Subject: River Bend Station
Docket No. 50-458
License No. NPF-47
Additional Information Related to License Amendment
License Amendment Request (LAR) 99-15, Changes to Technical Specifications
for Power Uprate of River Bend Station

Response to NRC Questions Related to River Bend Station Power Uprate Amendment

Enclosure 2
Response to NRC Questions Related to River Bend Station Power Uprate Amendment
(TAC NO.MA6185)

Summary Of Plots

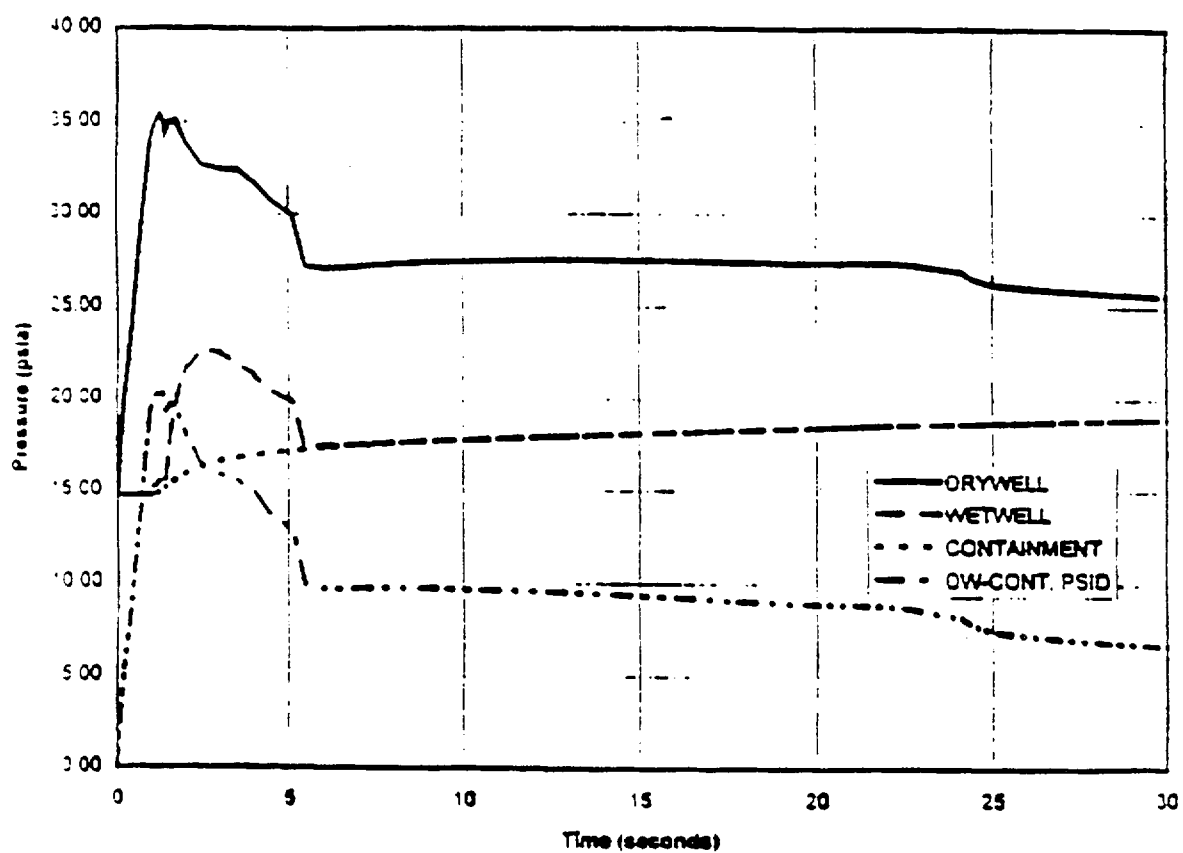
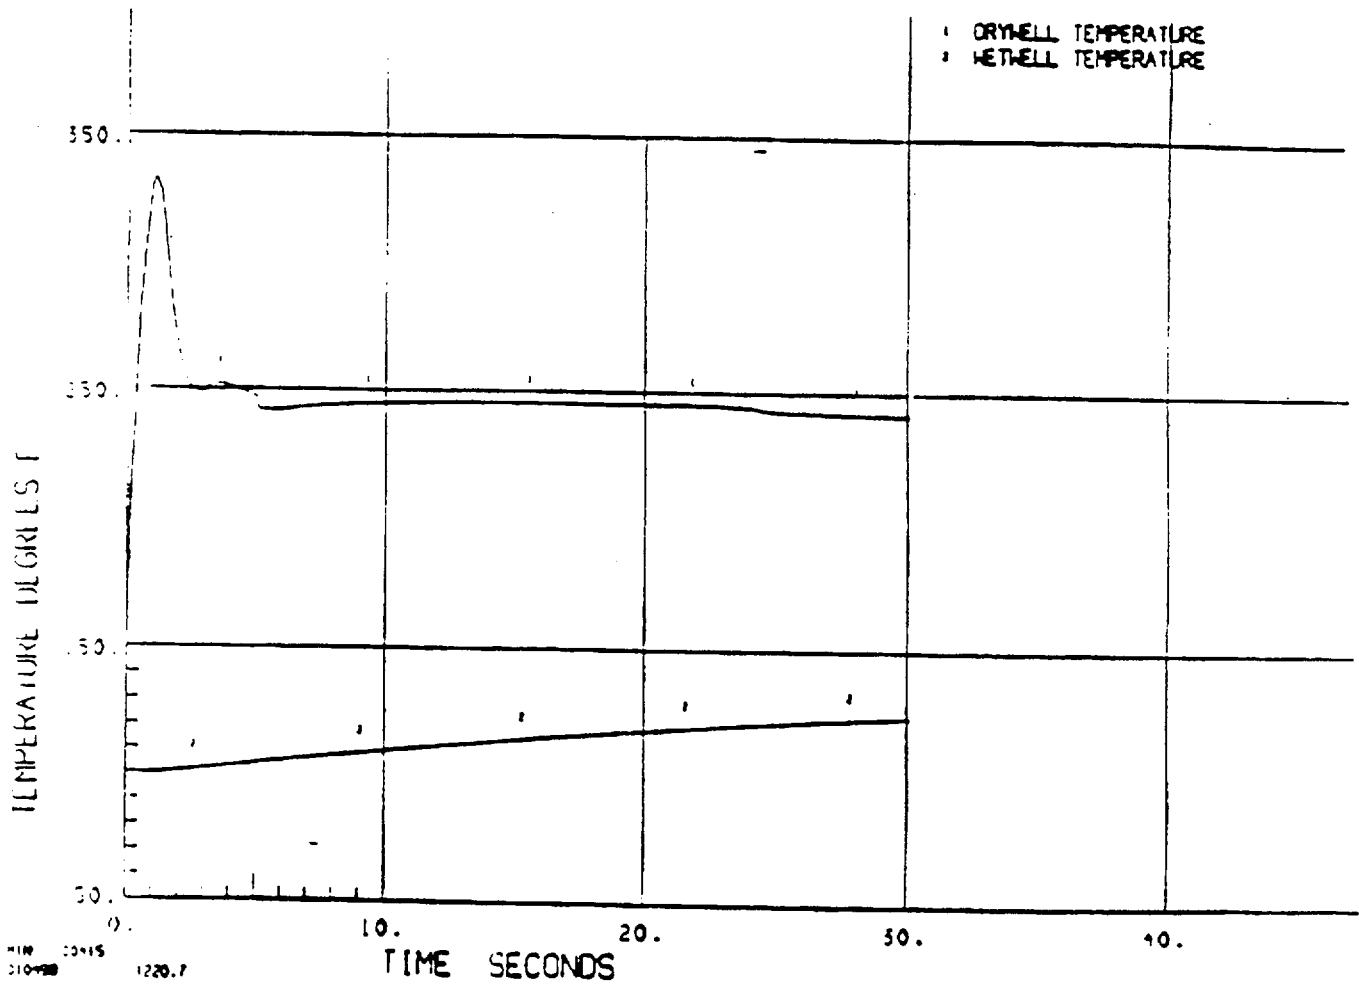
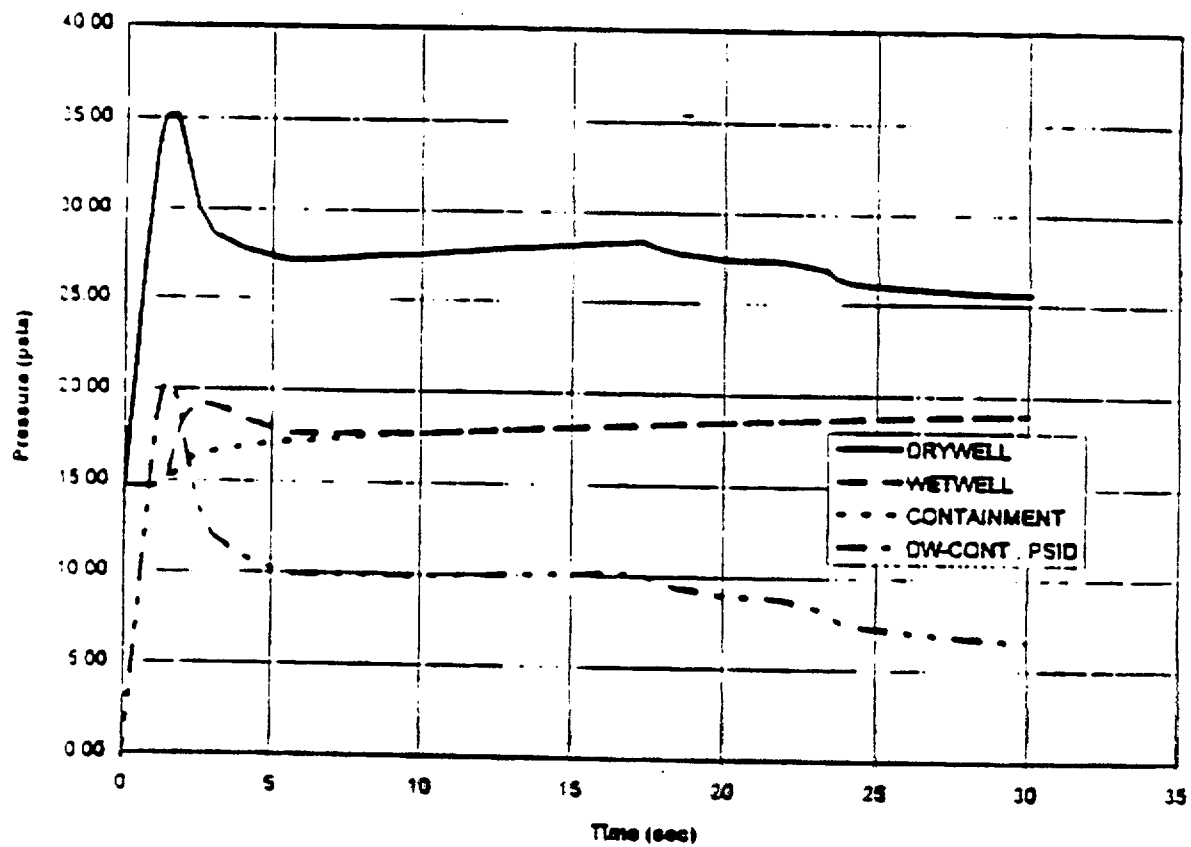
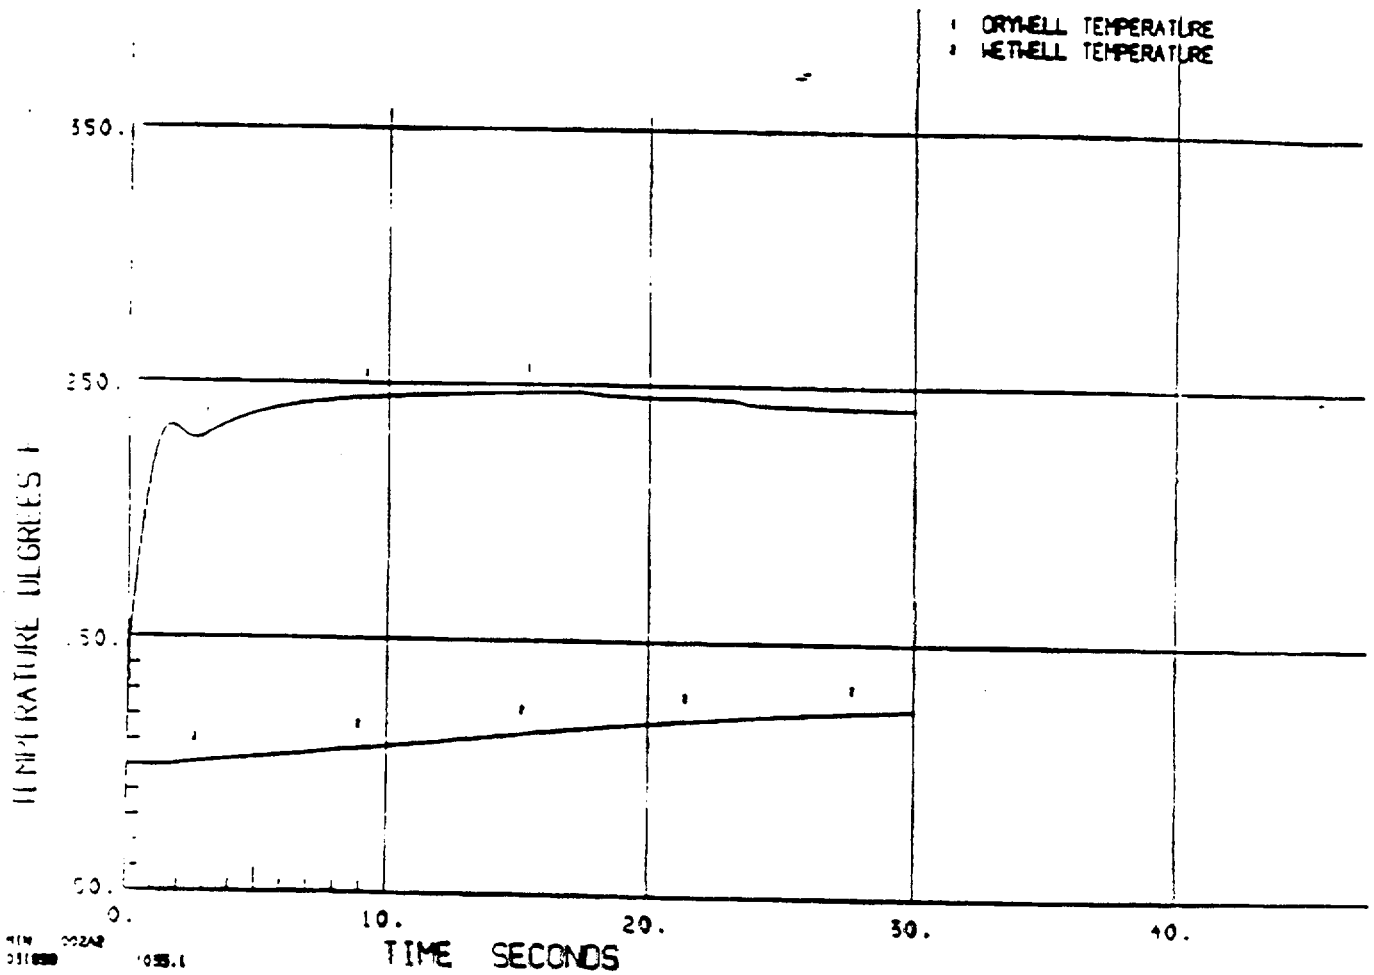
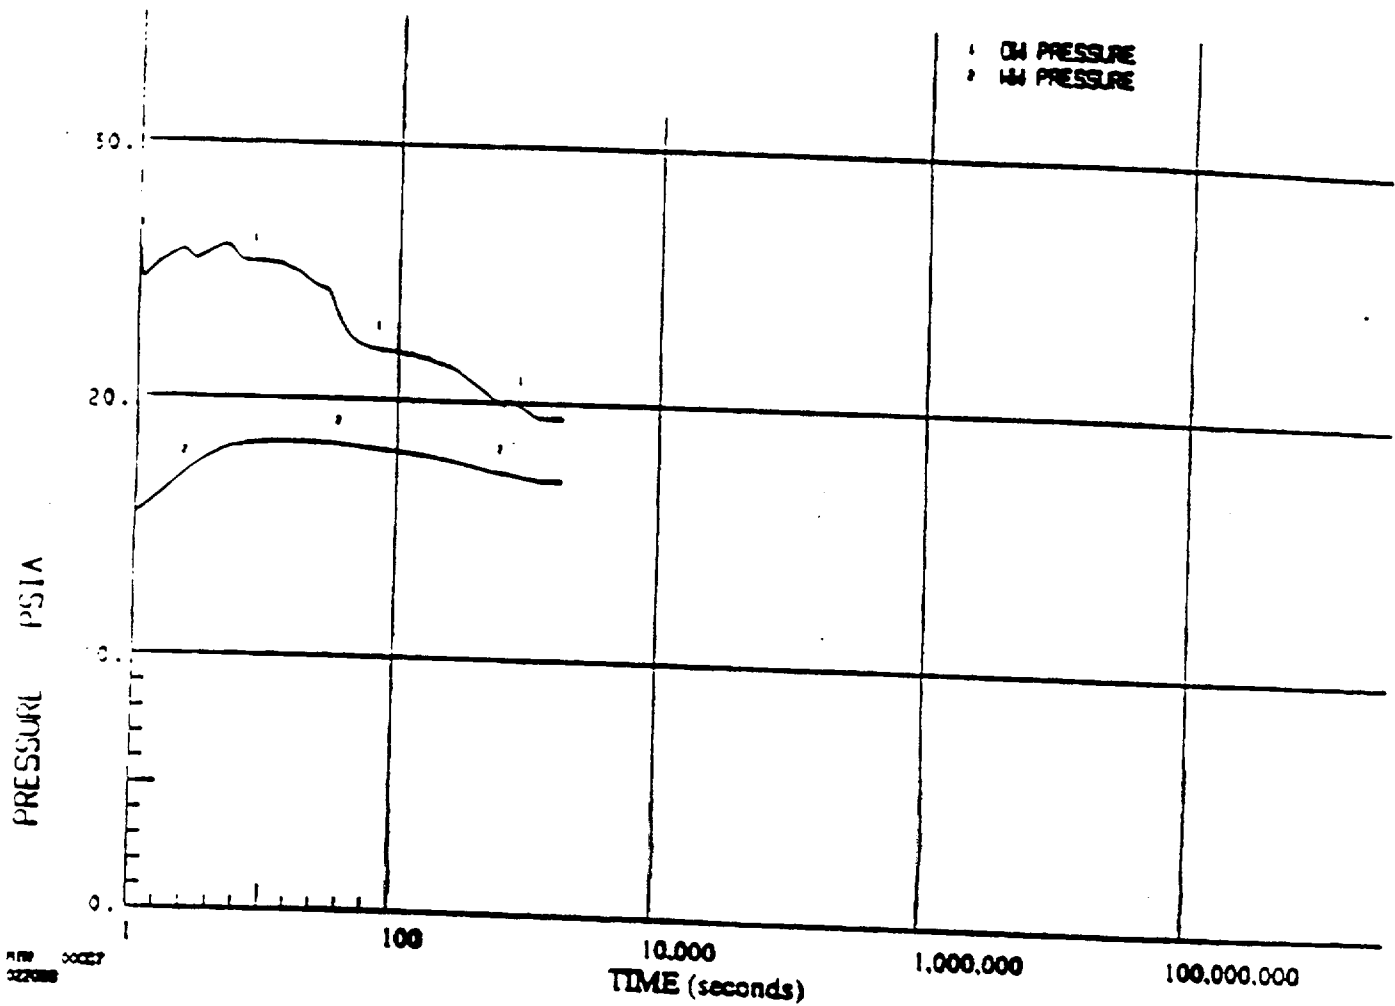
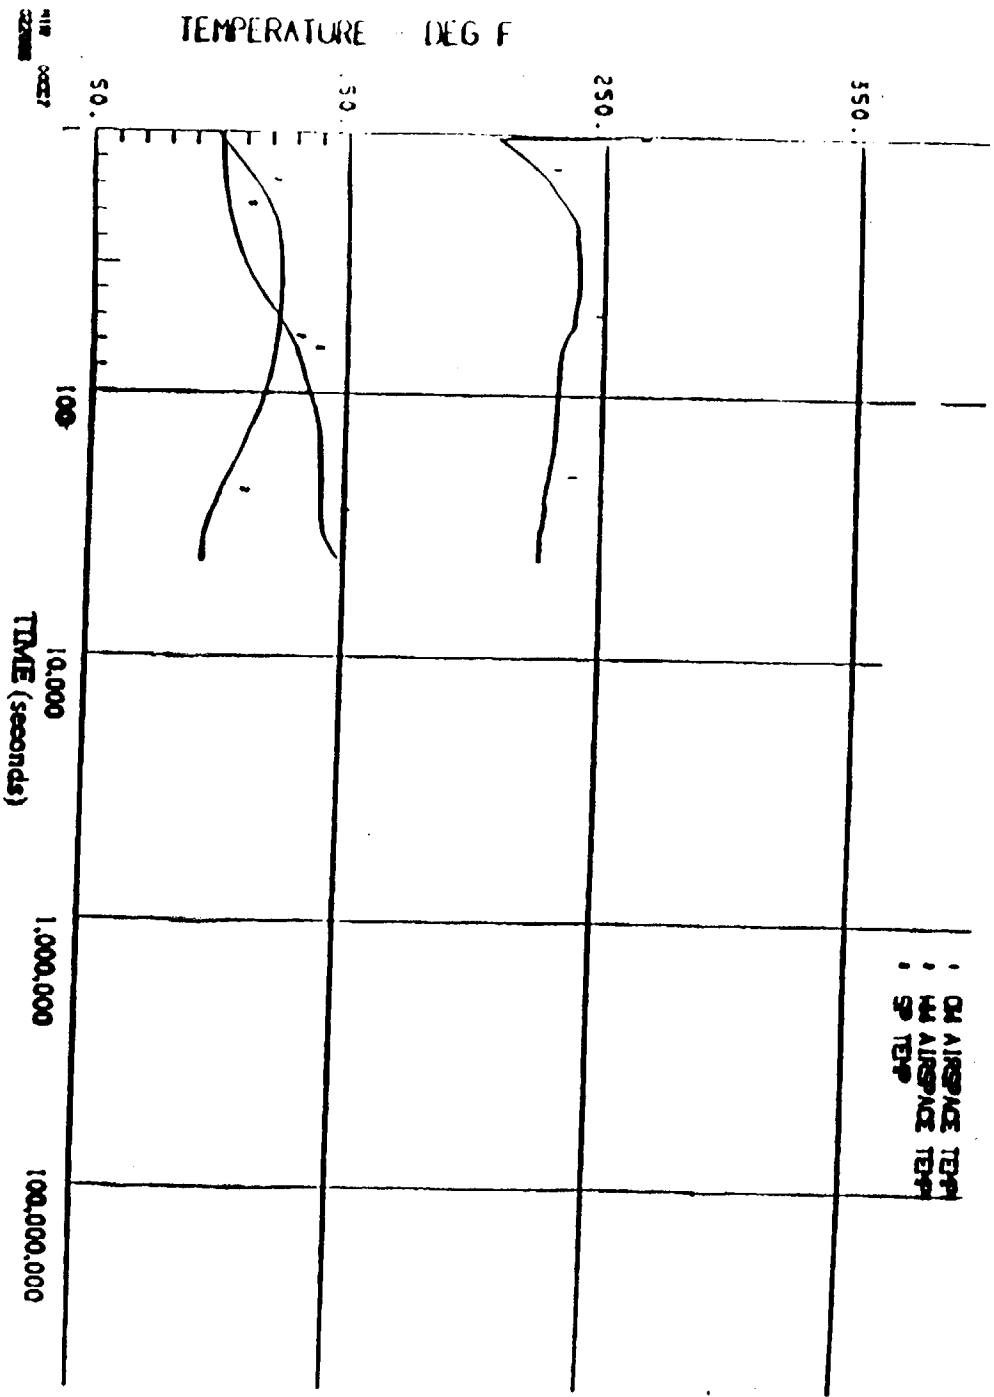
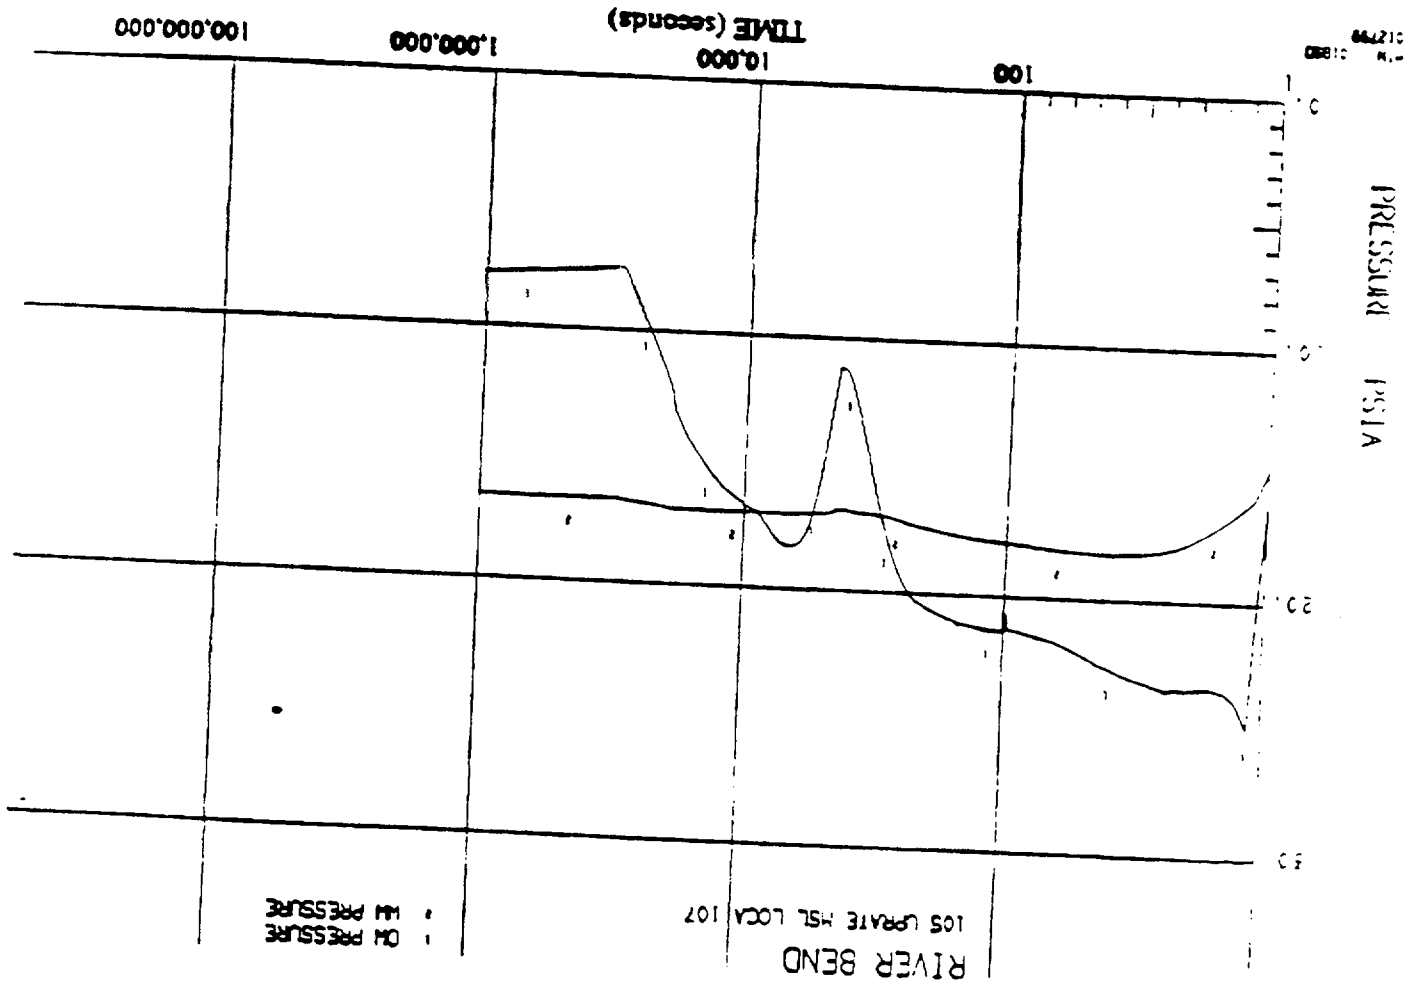
Question 5: Please provide the containment analyses maximum pressure and temperature curves at uprated power after a LOCA. Discuss the limiting initial conditions assumed for the DBA LOCA and for the sensitivity case for the MSLB for peak drywell pressure as indicated in Section 4 1.1.3. Also provide the containment drywell pressure limit in psig.

Response 5: Drywell & Containment Pressure Temperature Plots are attached at the end of this response. Please note that these figures are considered GE proprietary information. The original USAR analysis was based upon a nominal set of initial conditions. These results were supplemented by a sensitivity analysis to establish the range of acceptable conditions for the containment (Technical Specifications 3.6.1.4, 3.6.1.5, 3.6.2.1, 3.6.5.4, and 3.6.5.5). The following table summarizes the initial conditions, and key results for the nominal case, and significant sensitivities.

In the table above, the peak drywell temperature is shown to exceed the design limit by approximately 3 °F. This is discussed in Section 4.1.1.3 of NEDC-32778P. The computer program used to calculate the short term response does not include the impact of heat sinks on the temperature rise. If heat sinks are considered, the peak drywell temperature will not exceed 330 °F.

The current value of P_a used for containment testing is 7.6 psig, and is based upon the containment response assuming Technical Specification initial conditions. This value of P_a bounds the peak containment pressure calculated for uprate. Therefore, the value of P_a for containment testing will remain 7.6 psig.
